RE: Proposed Photovoltaic System, 200 Haynes Street, Response to Peer Review, Fire Department & Public Comments

Peer Review Comments from CMG

The grass swales were already labeled on the Drainage Plan (Sheet 6 of 9, see screen clip below).

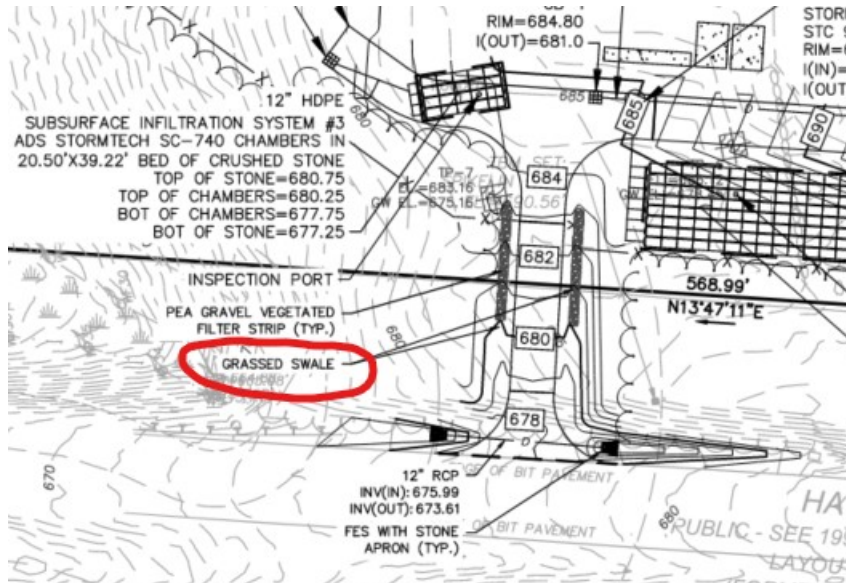
- How will runoff from the first 90± ft. of the proposed access driveway apron be routed and treated to prevent runoff flow into the Haynes Street roadway gutter line?

CMG Comment #2: Proposed grass swales should be called out on the Grading & Drainage plan sheets and a construction detail provided.

CMG Comment #3: Minor plan revision: still need to label grass swales on the plans.

BSC 11/20/23 Response: The proposed access driveway is crowned, directing runoff to the proposed grassed channels on either side of the driveway.

BSC 1/31/24 Response: The Drainage Plan sheet now calls out the proposed grass swales, and a cross-section of the driveway with both swales is included on Sheet 8 of 9 of the plan set.
